**Invitation to Bid (ITB)
ITB # 20-VSW-EMM-012**

Addendum Two

**Construction of All Season River Intake,
Emmonak, Alaska**

1 RAW WATER PUMPHOUSE ELECTRICAL PLAN

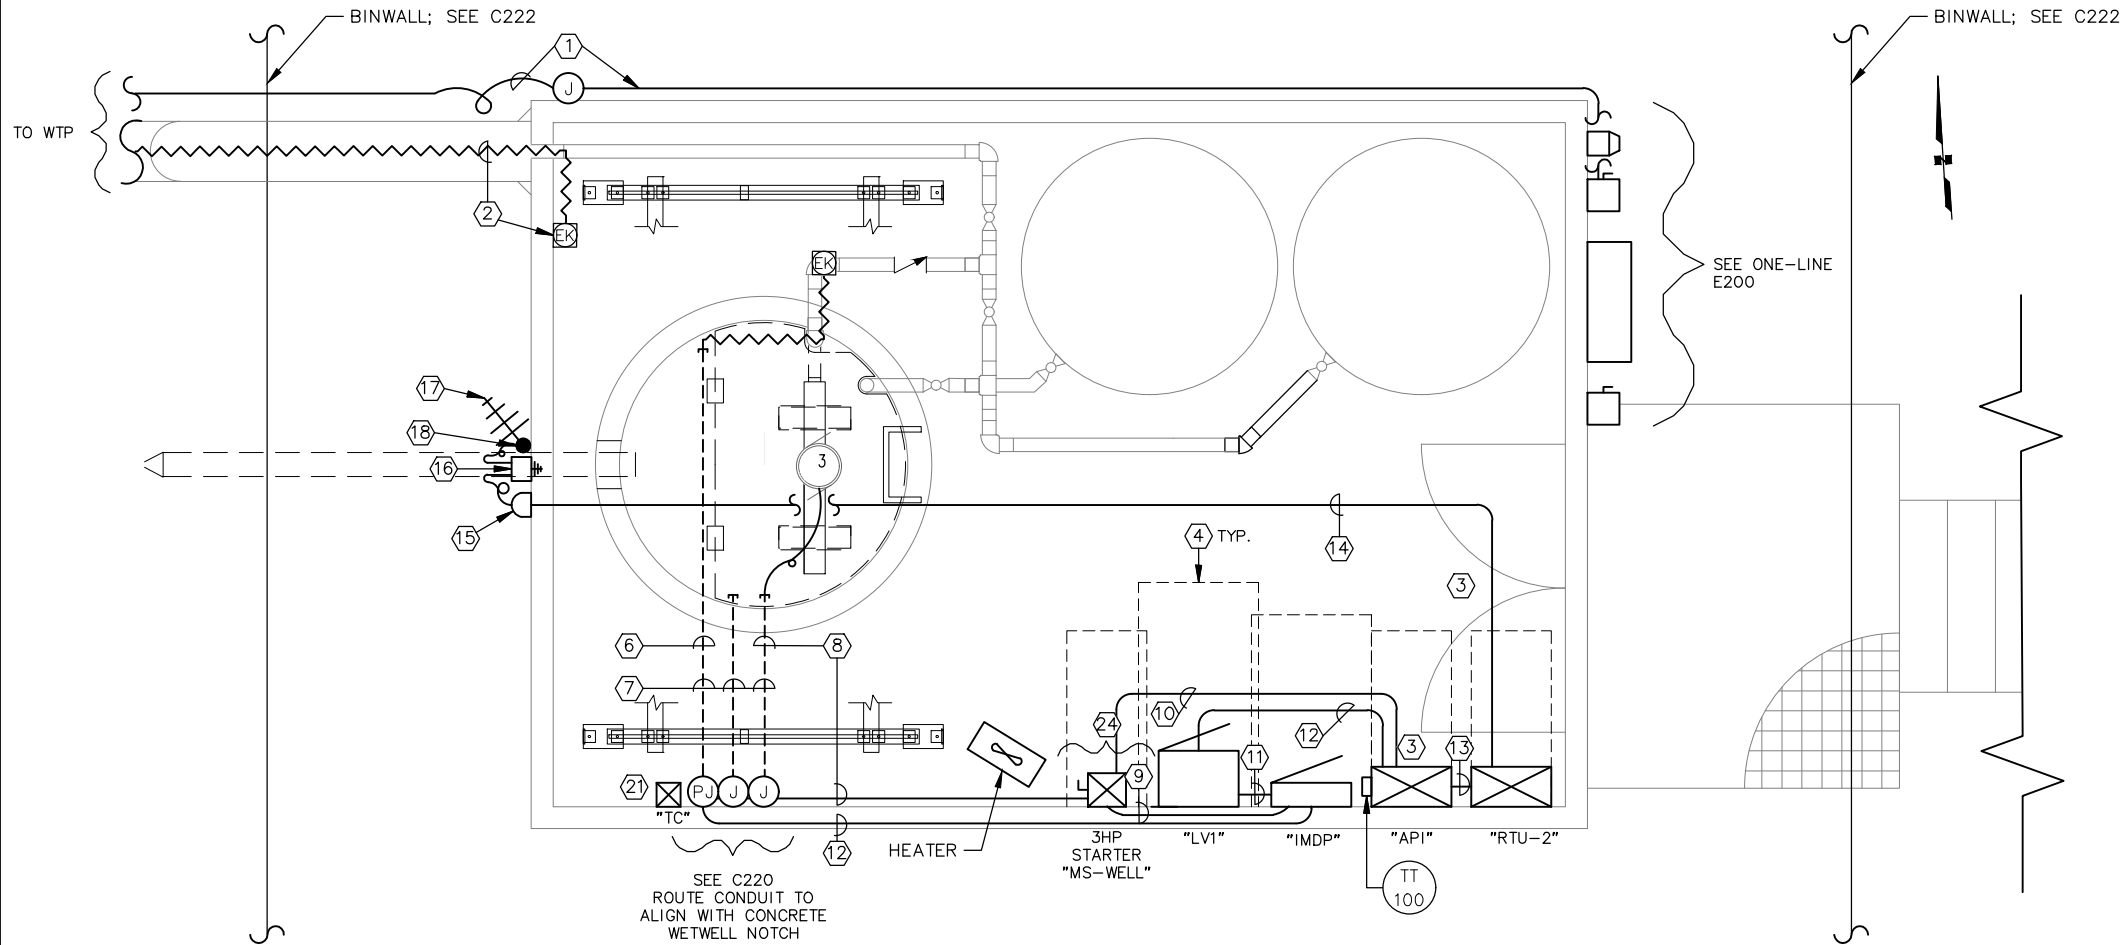
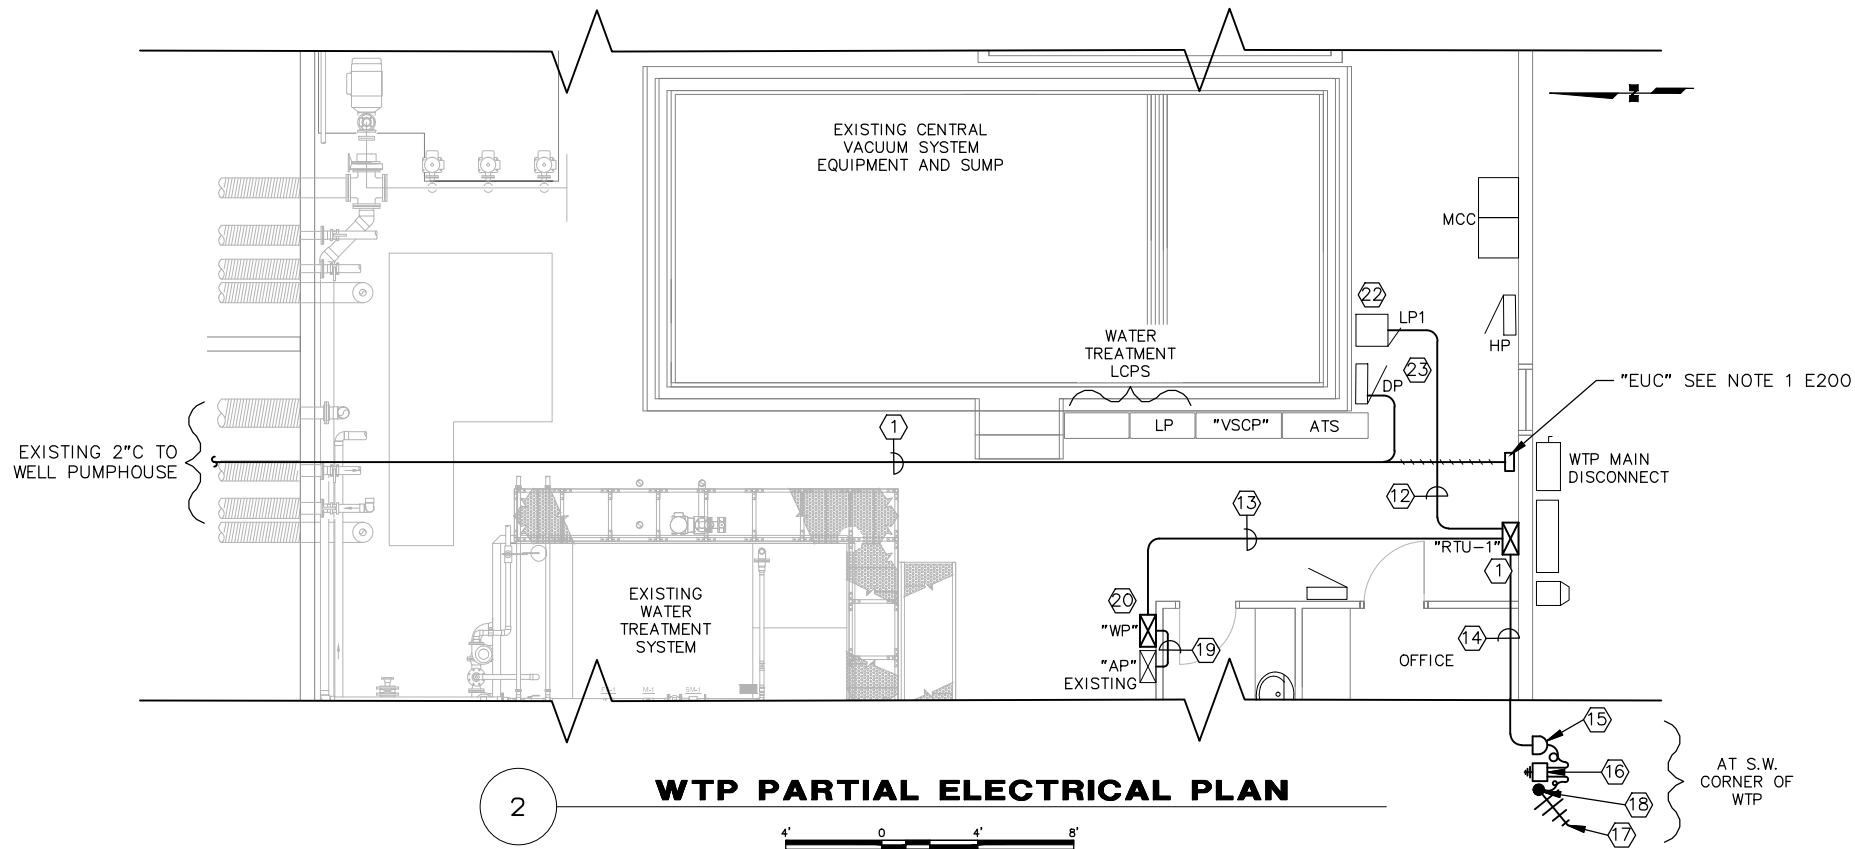
Detail 1 – Relocated "TC"
Detail 2 – Added location of "EUC" and move antenna location
Notes - Minor revisions to notes 7, 9, 18, 19, 20, 22, 23 and added note 24

Sheet No. **E401**

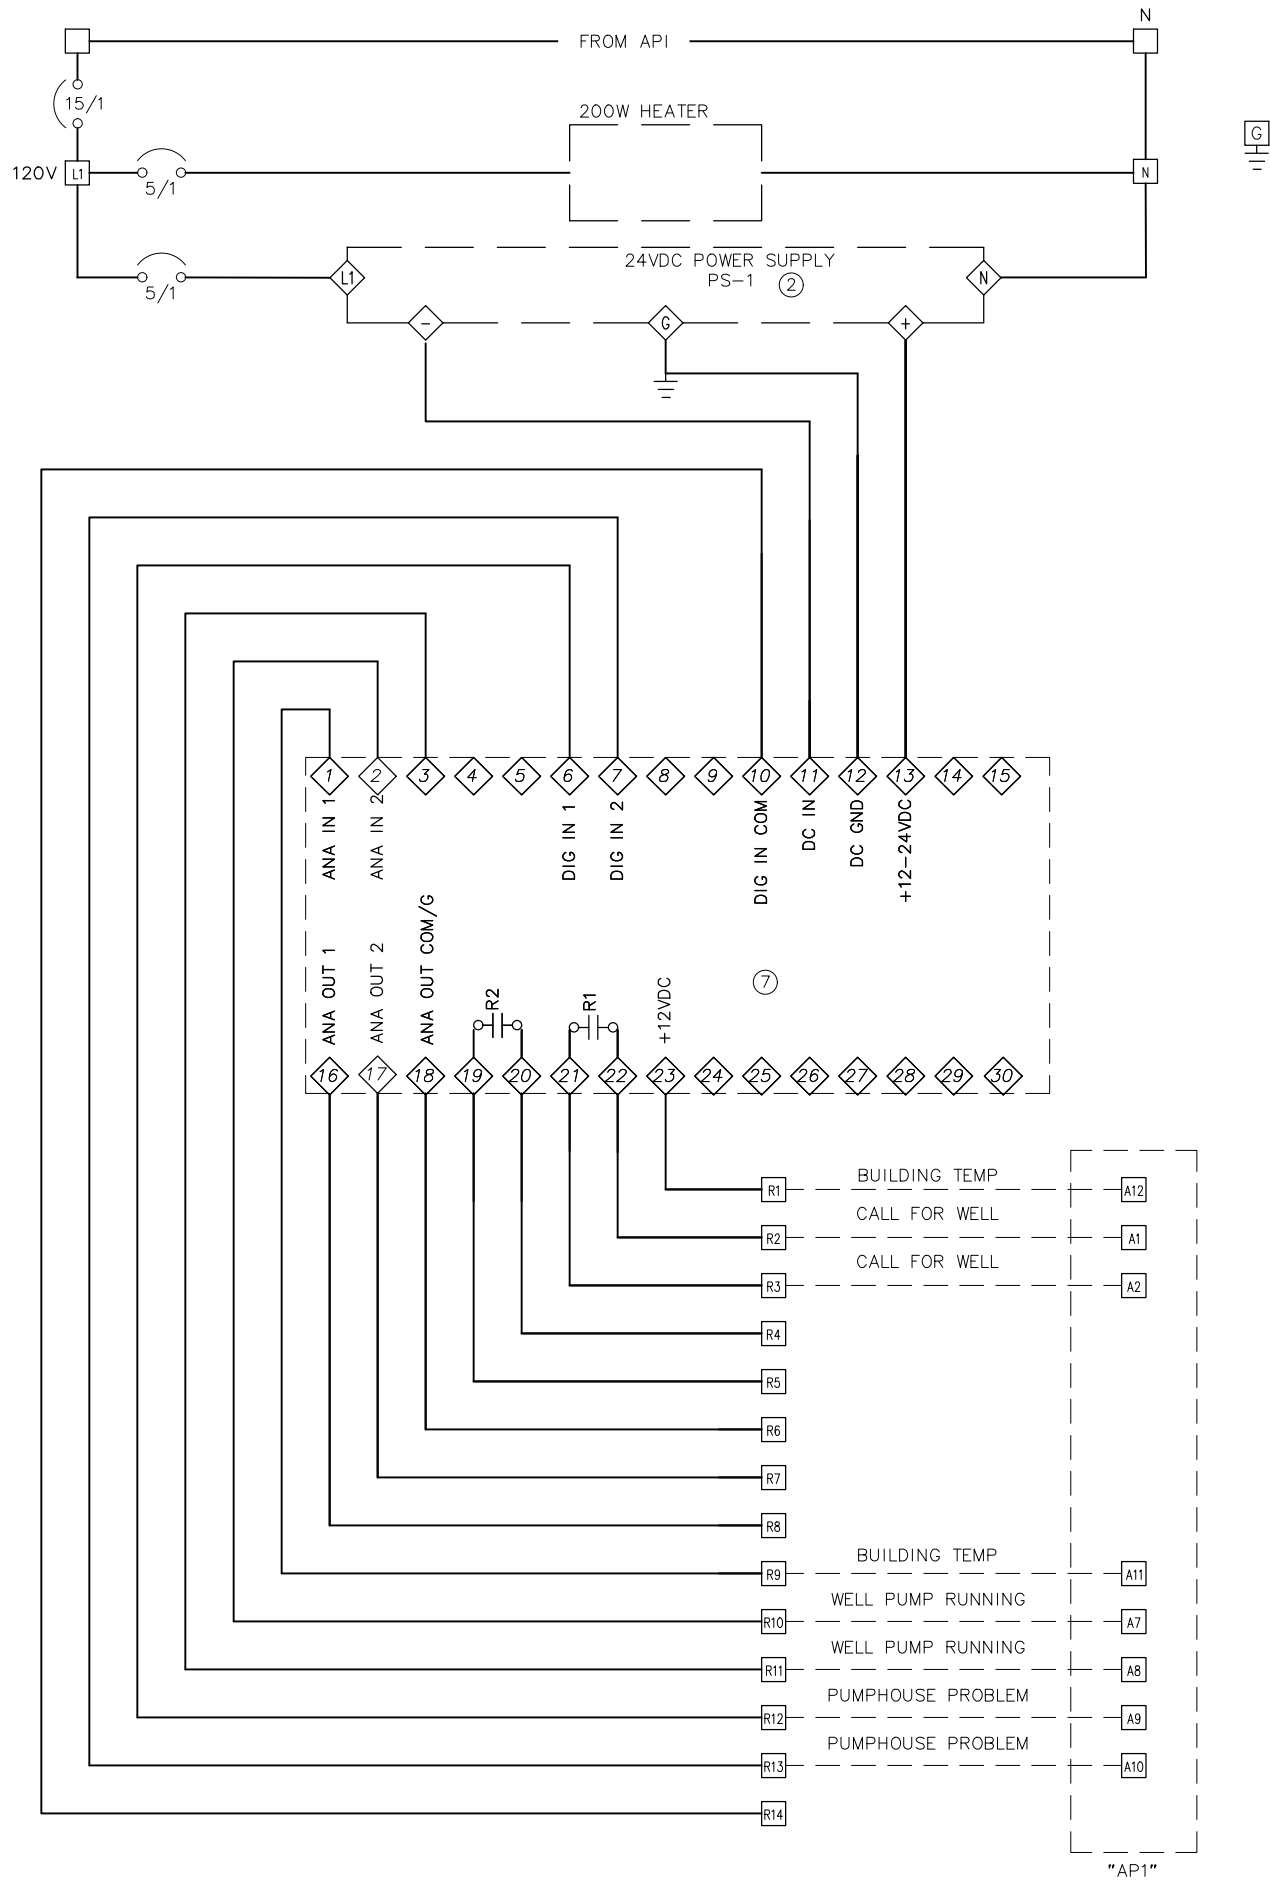
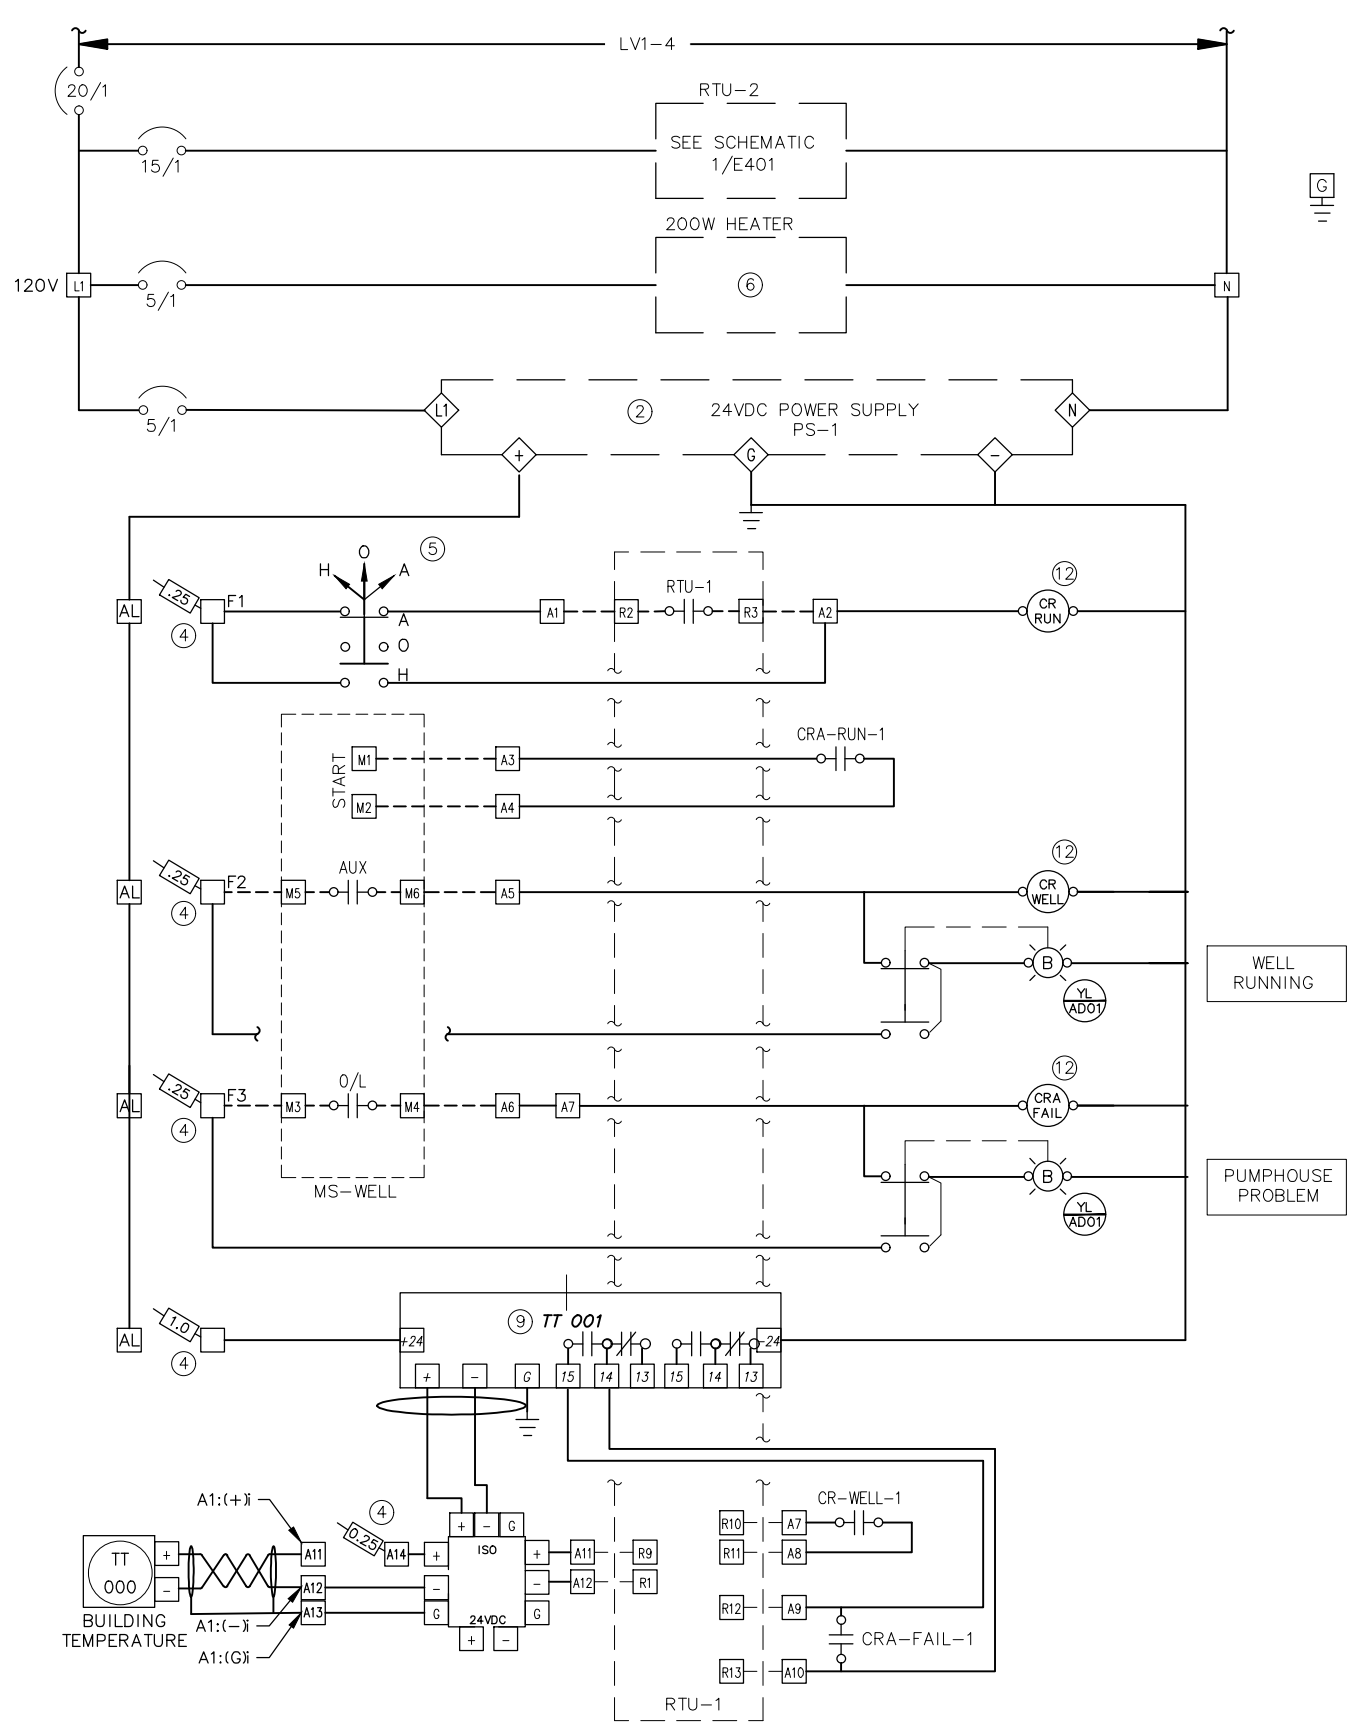
Added component labels and minor clarifications
